[Docket No. FAA-2022-1647; Project Identifier AD-2022-01379-T; Amendment 39-22438; AD 2023-10-02]

Airworthiness Directives; Transport and Commuter Category Airplanes

ACTION: Final rule.

Figure 1 to paragraph (g)(1)(i)—*Fundamental Effective Isotropic PSD at Outside Interface of Airplane Antenna*

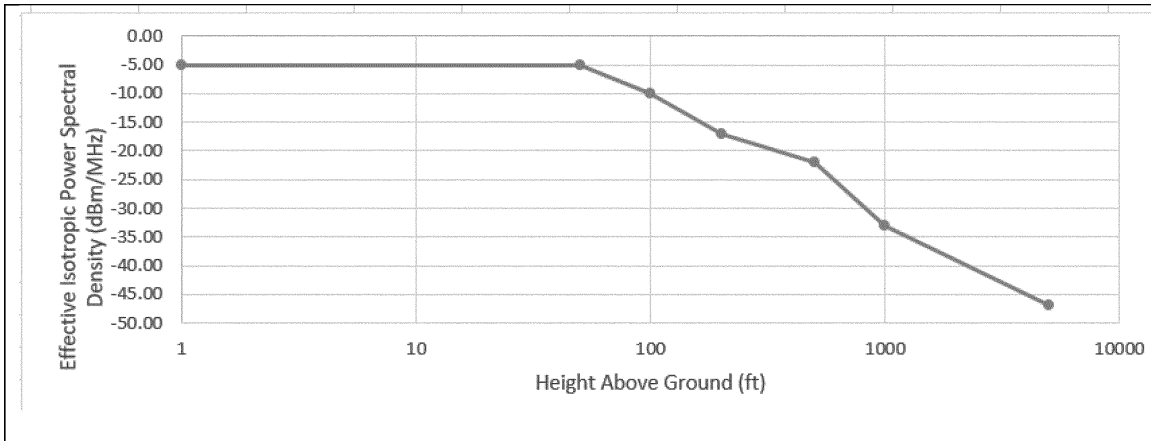
Comment summary: Textron Aviation requested the FAA clarify at what reference point the PSD requirements apply. The commenter stated it assumed that they apply at the radio altimeter receive antenna input, such that antenna characteristics, coax loss, and filter characteristics would be included in the determination.

FAA response: The FAA agrees and has changed the title of figure 1 to paragraph (g)(1)(i) of this AD to reflect that the PSD requirements apply at the

antenna input to the radio altimeter, and that the figure applies to the outward facing side of the antenna.

Figure 2 to paragraph (g)(1)(ii)—*Spurious Effective Isotropic PSD at Outside Interface of Airplane Antenna*

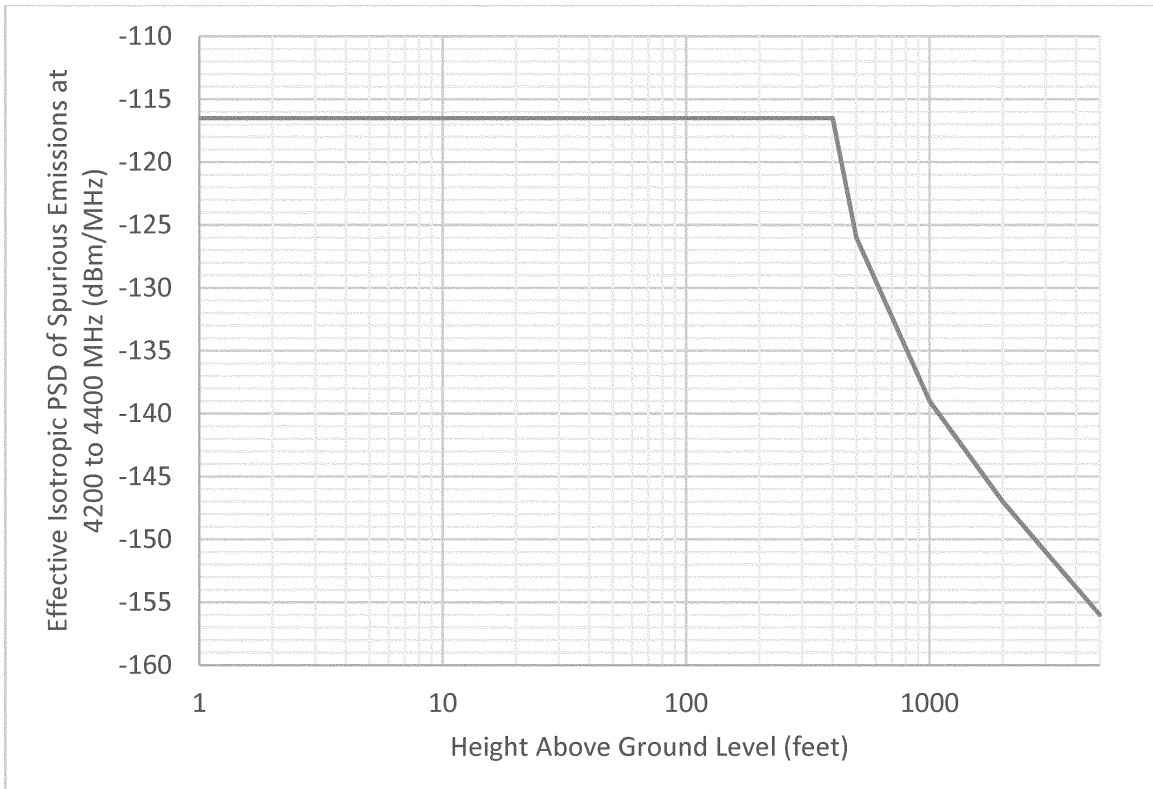
Comment summary: AIA requested that the FAA provide more information about the tolerances for determination of whether an airplane is radio altimeter tolerant. Several commenters requested that the FAA add a new figure indicating the spurious tolerance, similar to the figure with the PSD tolerance curve, and a specification of the altitude dependence for spurious tolerance.

FAA response: The FAA agrees and has replaced the proposed fixed emission level with a spurious PSD tolerance curve in figure 2 to paragraph (g)(1)(ii) of this AD. Subsequent figures have been redesignated accordingly.
